DAM SAFETY INSPECTION REPORT

**TROWBRIDGE DAM
ID #00604
SW 1/4 SEC 12. T1N, R13W
KALAMAZOO RIVER
ALLEGAN COUNTY**

INSPECTION DATE: April 16, 2004

REPORT DATE: July 12, 2004

TROWBRIDGE DAM, LEFT EMBANKMENT

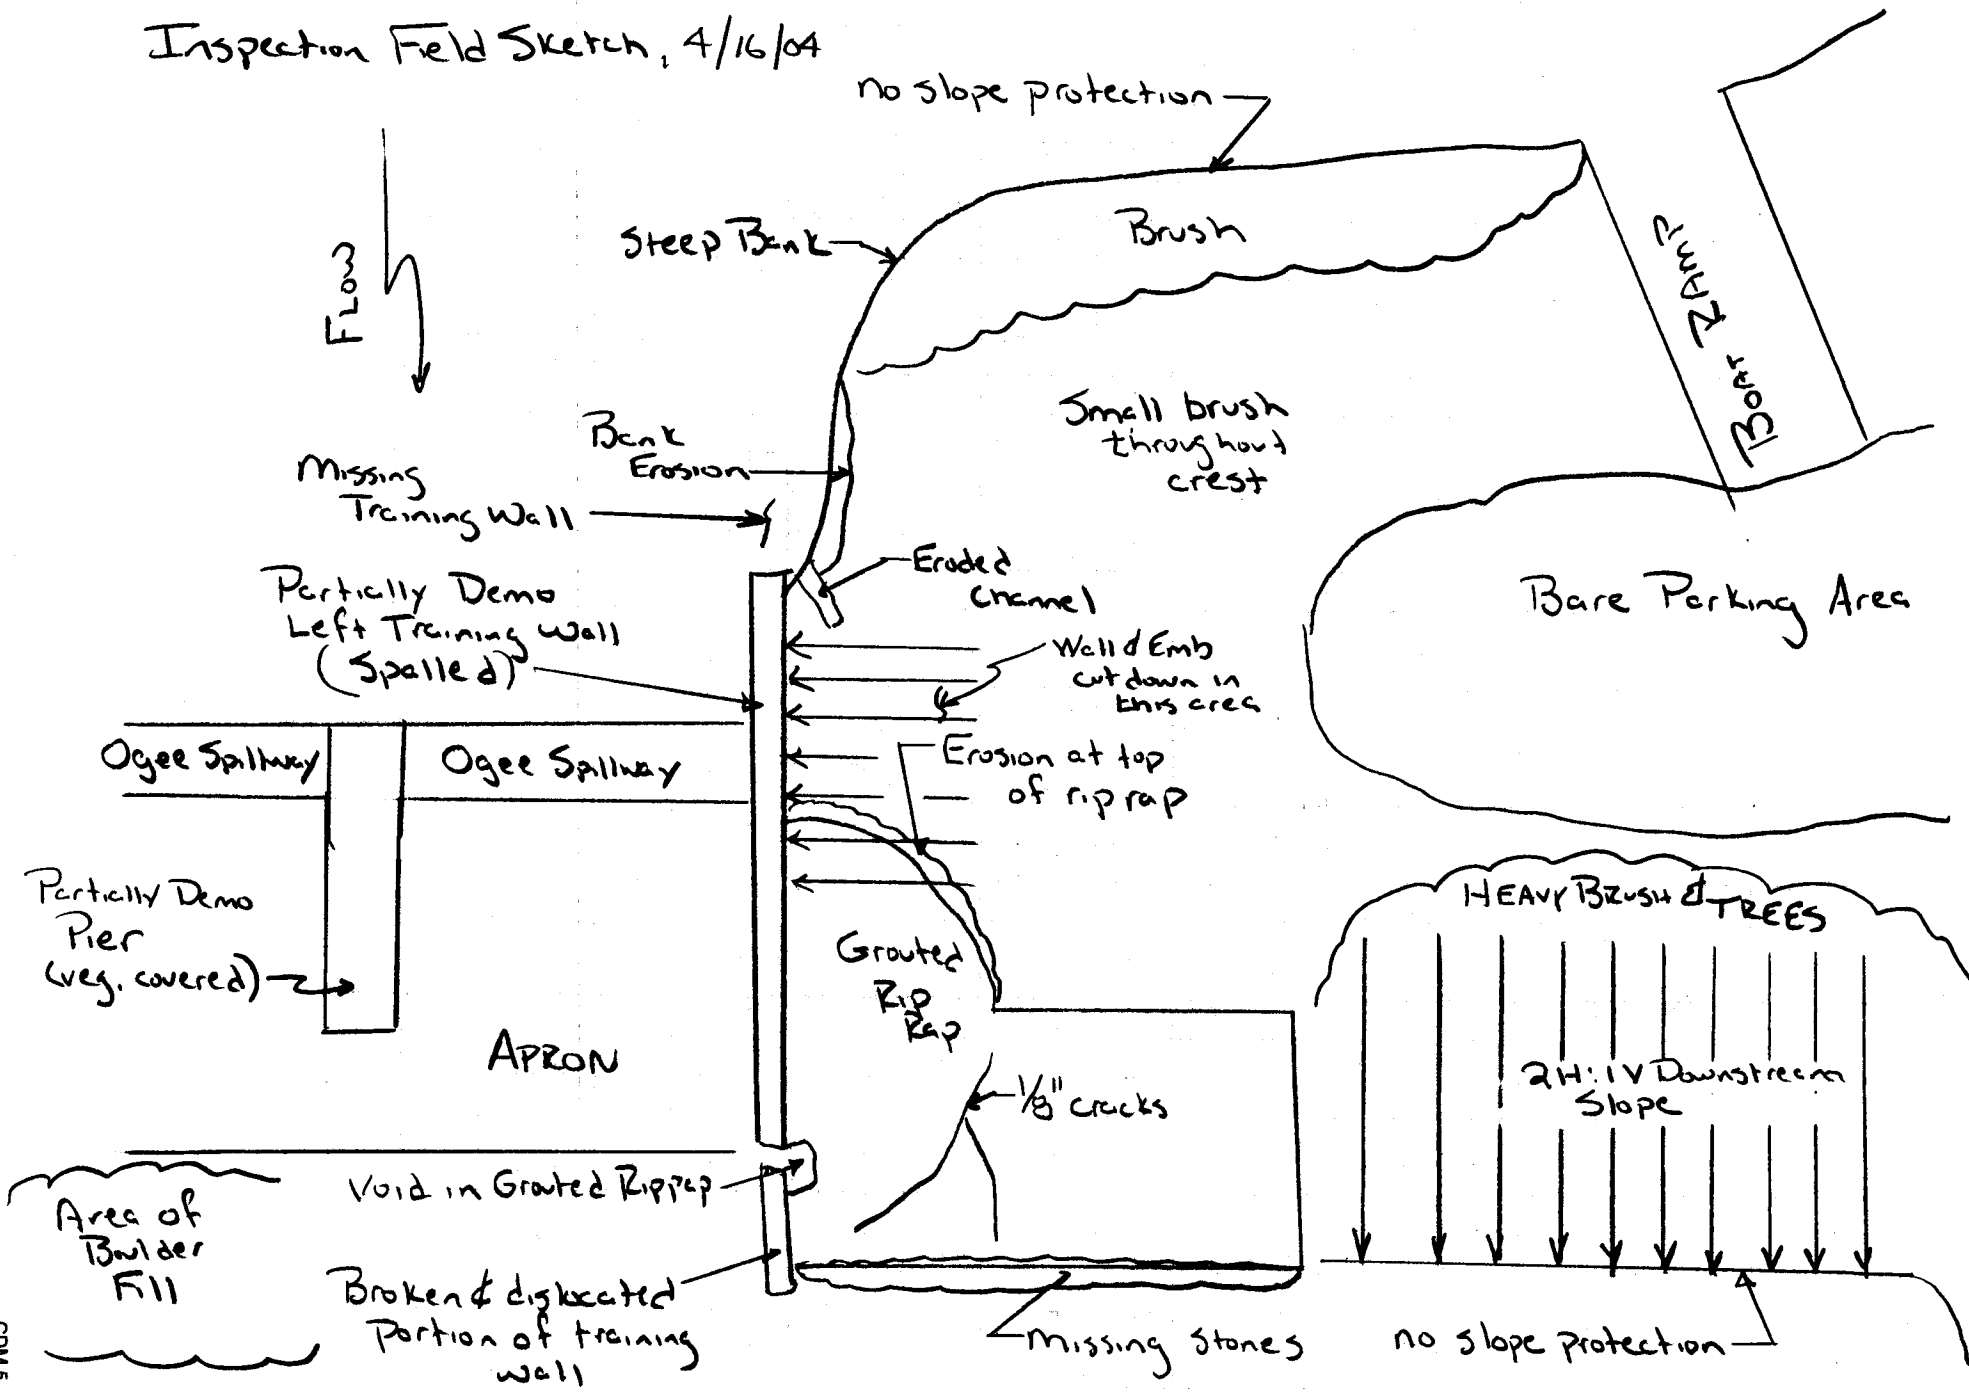
- Upstream portions of the right training wall are missing, causing water flow to move rapidly across the embankment on the right side.
- Upstream portions of the left training wall are missing, causing an area of the left upstream embankment to slough into the river.

- The missing training wall and low area of the embankment appears to allow overtopping behind the left training wall. Overtopping and/or surface water runoff are causing an erosion path in the upstream area and causing loss of topsoil from around the grouted riprap on the downstream side of the embankment.

- Brush and trees are present on the upstream and downstream areas of each embankment. No upstream erosion protection is present. In addition, areas of the left downstream embankment slope, where in contact with backwater pool, also require erosion protection.

- Cracks, 1/8-inch open, were observed in the grouted riprap on the left embankment. Cracks may be due to shrinkage or some movement, but appear to be stable over the last several visits.

- Parking area on top of left embankment is bare and required either grass or gravel protection.
- The area around the former powerhouse is low and continues to be an area overtopped during storm events.

- Erosion paths on upstream left embankment and downstream right embankment.
- Missing stones from toe of grouted riprap where grout penetration was inadequate.

- The entire left and right embankments should be re-graded, removing all trees and brush, and shaped with an even crest with upstream and downstream slopes no steeper than 3 horizontal to 1 vertical. The upstream slope of the re-graded spillway should be protected by riprap with grass planted over the remainder of the spillway. Additional slope protection should be provided on the downstream slopes in the range of potential backwater levels against the dam.

- Fill all erosion paths on the upstream and downstream areas of the embankment and abutments and vegetate with grasses.
- Fill around edges of grouted riprap and patch or seal cracks in riprap surface. Provide additional riprap at downstream edge of grouted riprap to avoid further loss of riprap.

- Provide gravel or other surface protection in parking area on top of left embankment.

TROWBRIDGE DAM, RIGHT EMBANKMENT
NOT TO SCALE
Inspection Field Sketch, 4/16/04

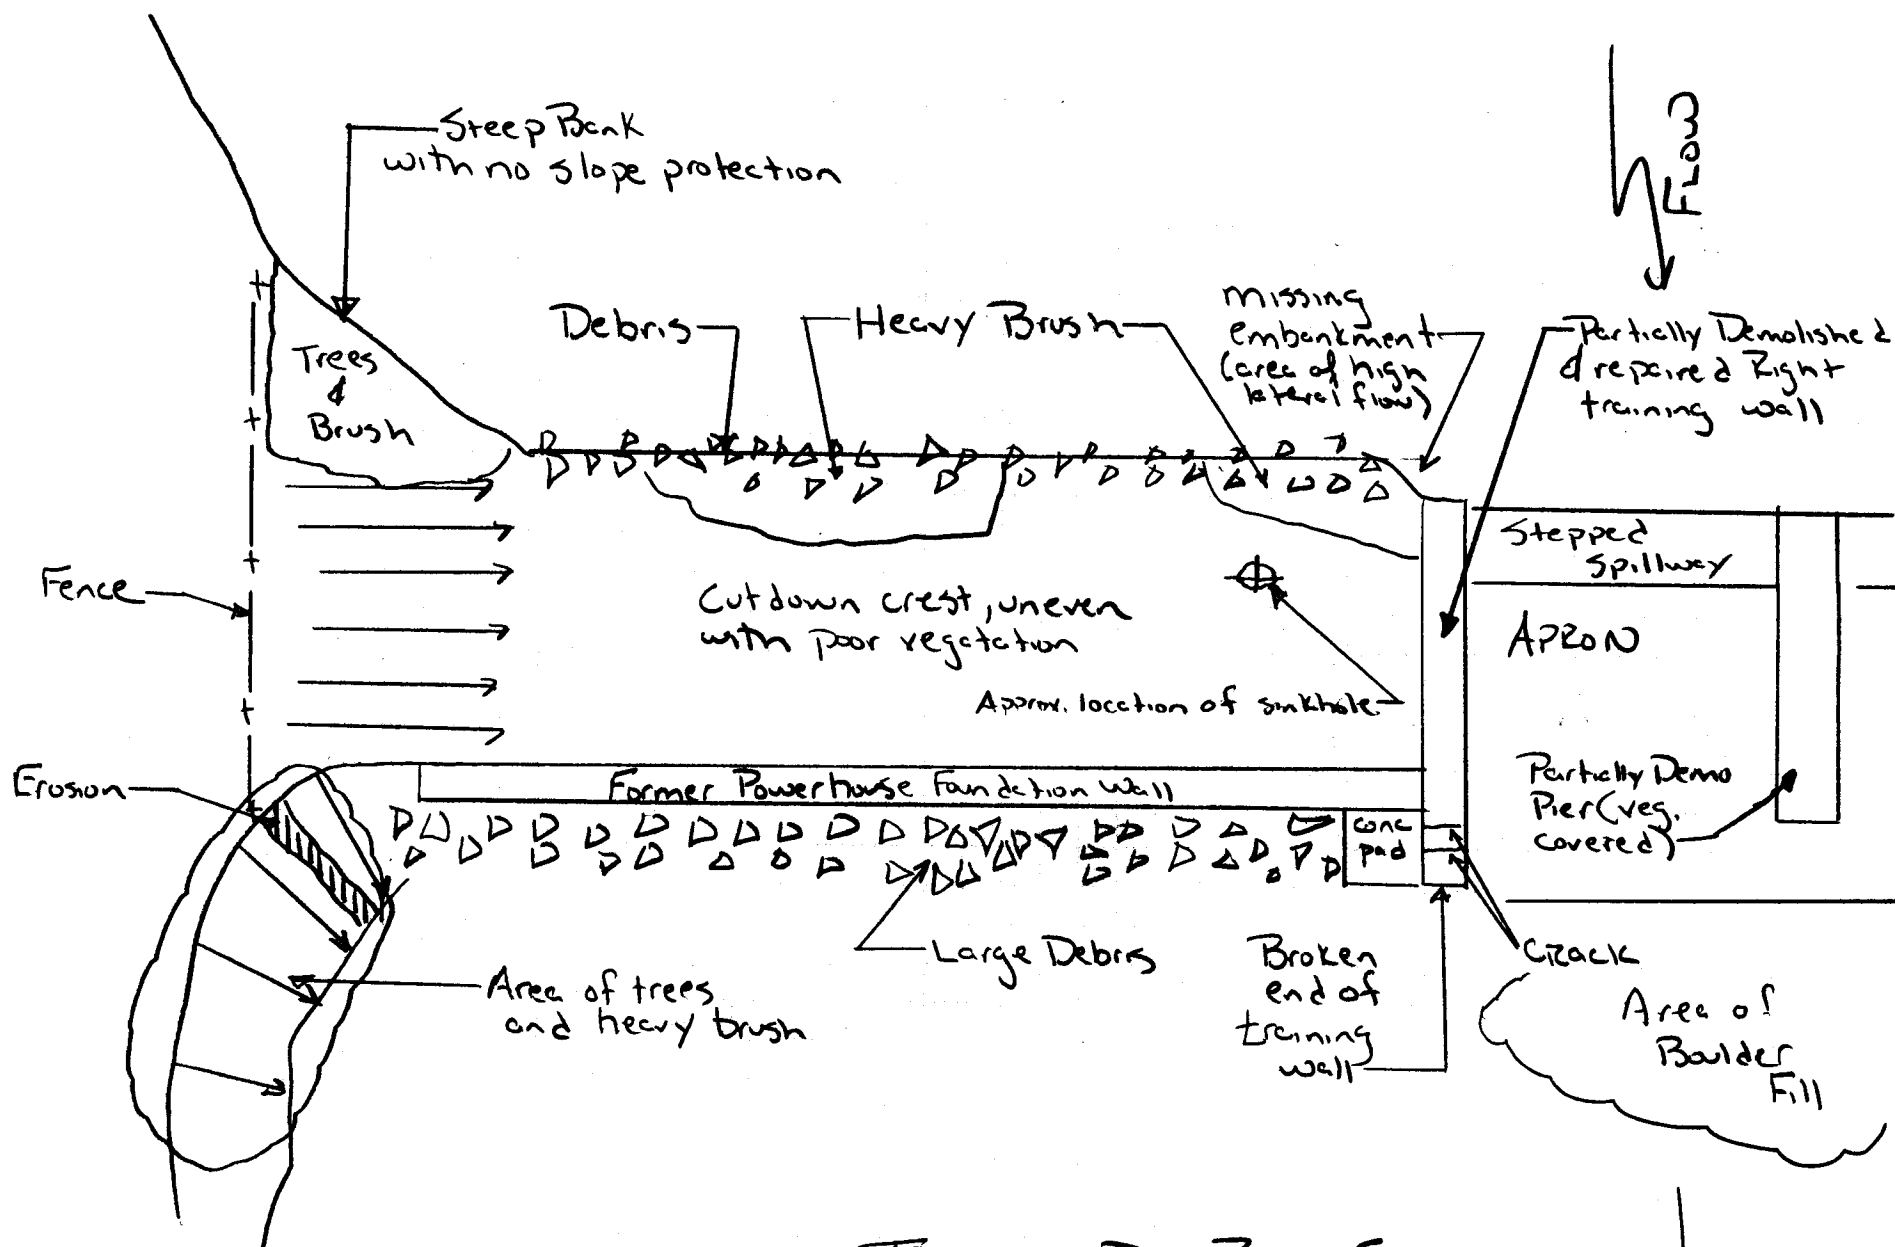
- In general, the right embankment is uneven with a low area at the former powerhouse with demolition debris covering most of the embankment. The upstream edge is highly uneven with water forming pools in the debris as much as 15 feet into the embankment. A sinkhole/seepage path was seen on a former visit. Dye testing confirmed that it exited from below the right training wall foundation.

- While not leaking at the time of this visit, recent visits during higher pool conditions have shown significant leakage through the embankment at the former powerhouse location. Continuing uncontrolled leakage could cause internal erosion of the embankment, ultimately leading to dam failure.

- Downstream areas of apron and training walls are broken off and missing. The large void which formed at toe of dam is filled with boulder fill as an energy dissipater. Boulder fill appears to be remaining in place.

- Reconstruct the downstream portion of the spillway including the entire downstream apron which has broken off. Repair and underpin or entirely replace the spillway as required to provide adequate foundation support, patch deteriorated concrete and fix the hole recently created in the spillway ogee section. Replace missing sections of training wall upstream of spillway to avoid erosion of embankment.

- Further investigate and grout or otherwise cut off seepage through the dam including the sinkhole/seepage path which exits below the right training wall foundation and seepage through the former penstocks and powerhouse.
